GRW Record Drawings

FALL CREEK REGIONAL WASTE DISTRICT SANITARY SEWER REHABILITATION PROJECT PHASE I

PENDLETON, INDIANA

*Pendleton
Phase I
As-built*

PROFILE - STA. 24+46 TO STA. 10+50 LINE "A"

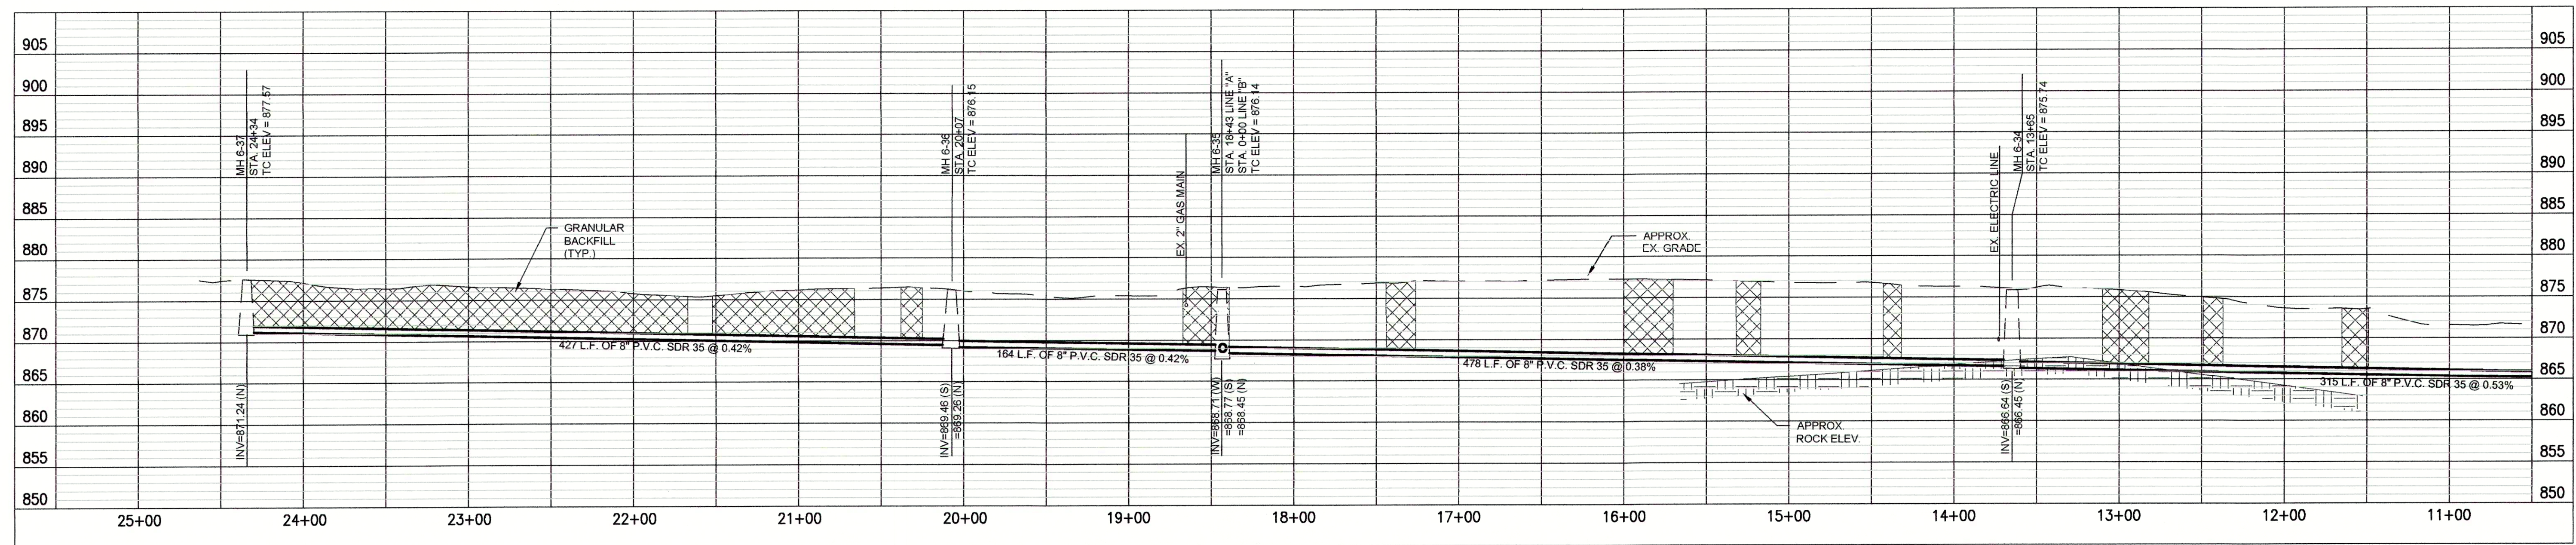
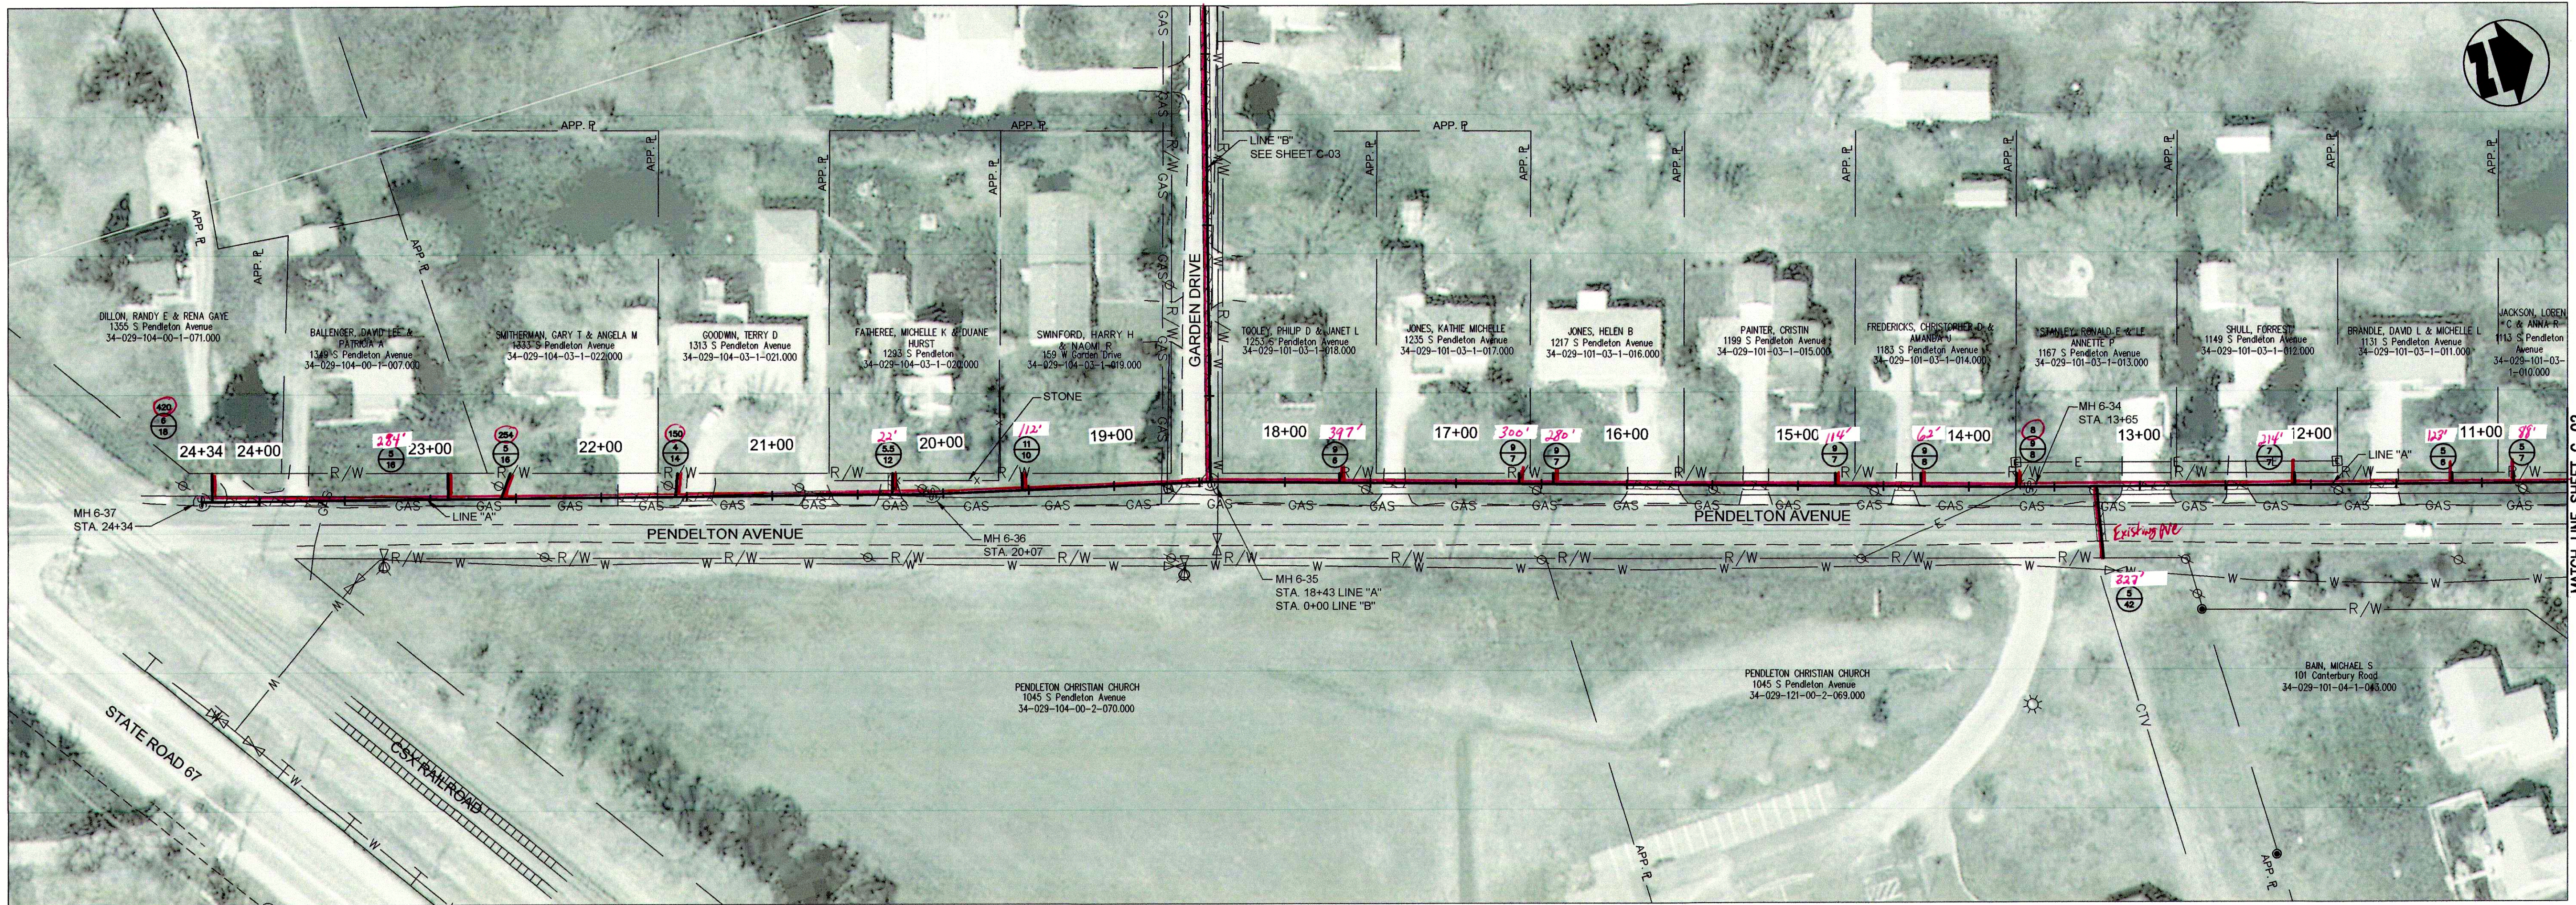
From MH# 6-37 to MH# 6-30 - CIPP

SHEET NO. C-13 A

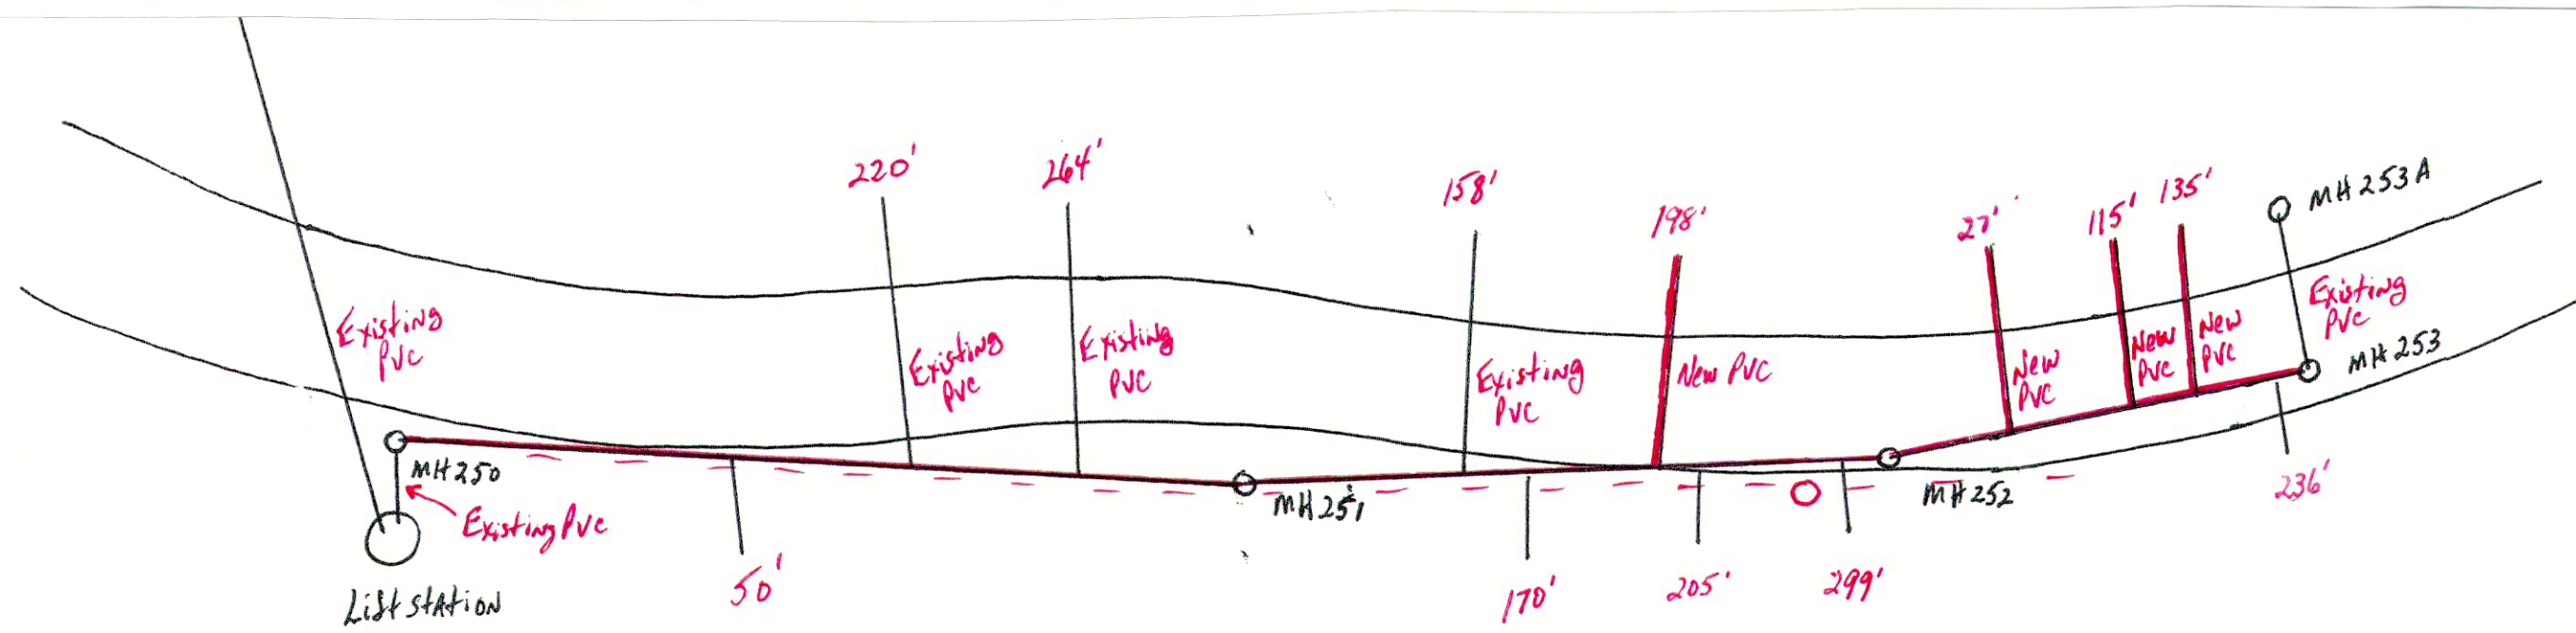
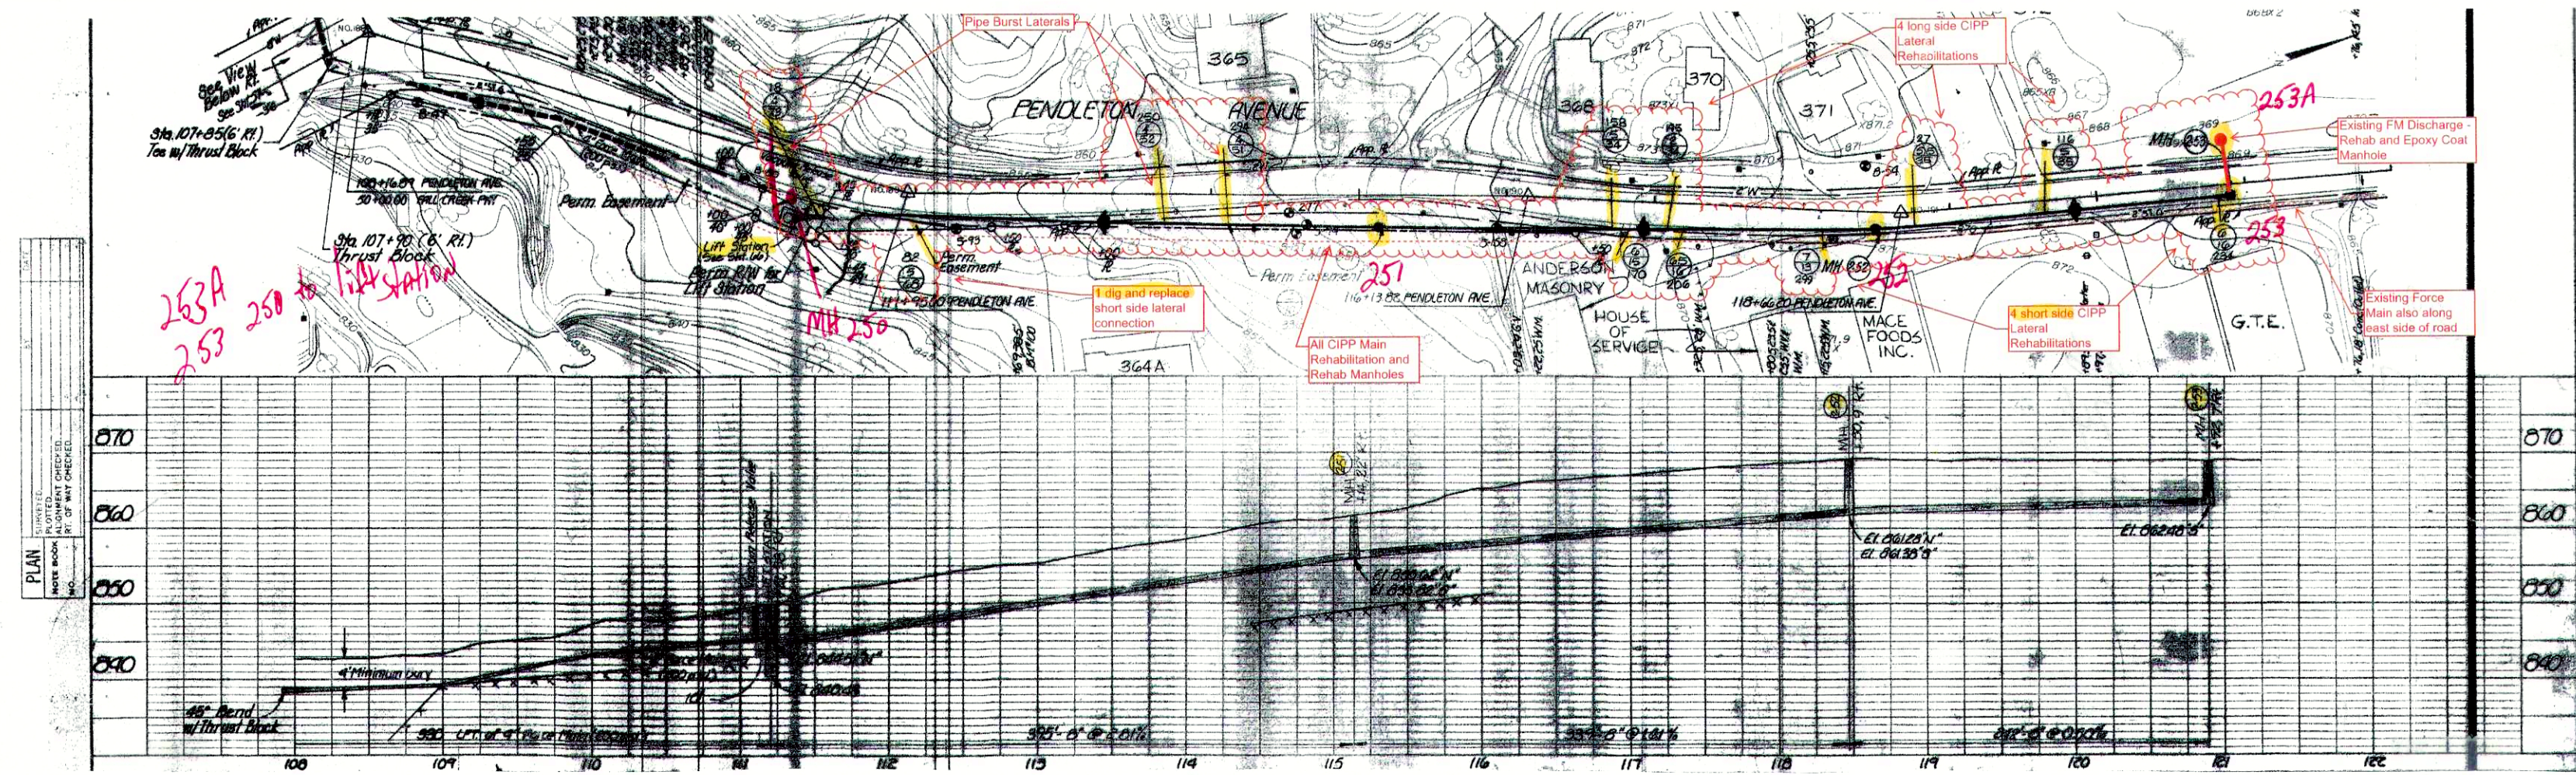
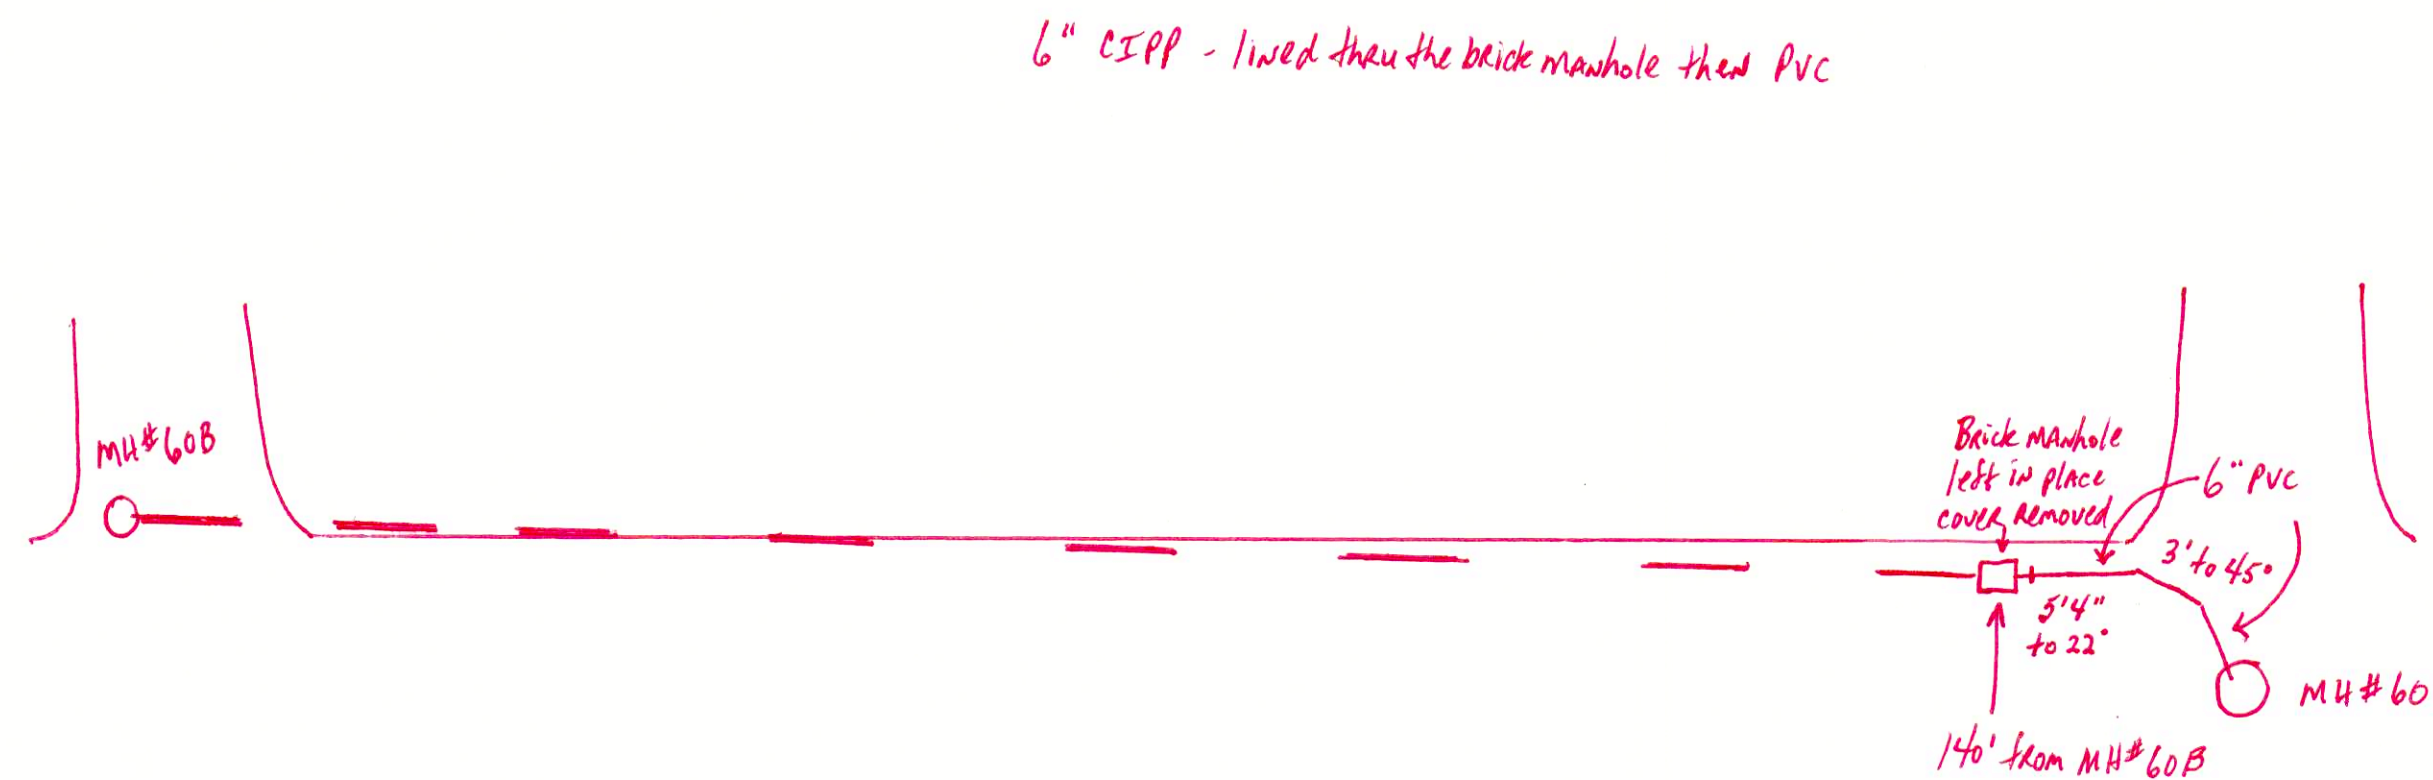
MH#250 to MH#253 CIPP

Existing force main on east side of the road
Rehab all manholes/epoxy coat

6" CIPP - lined thru the brick manhole then PVC
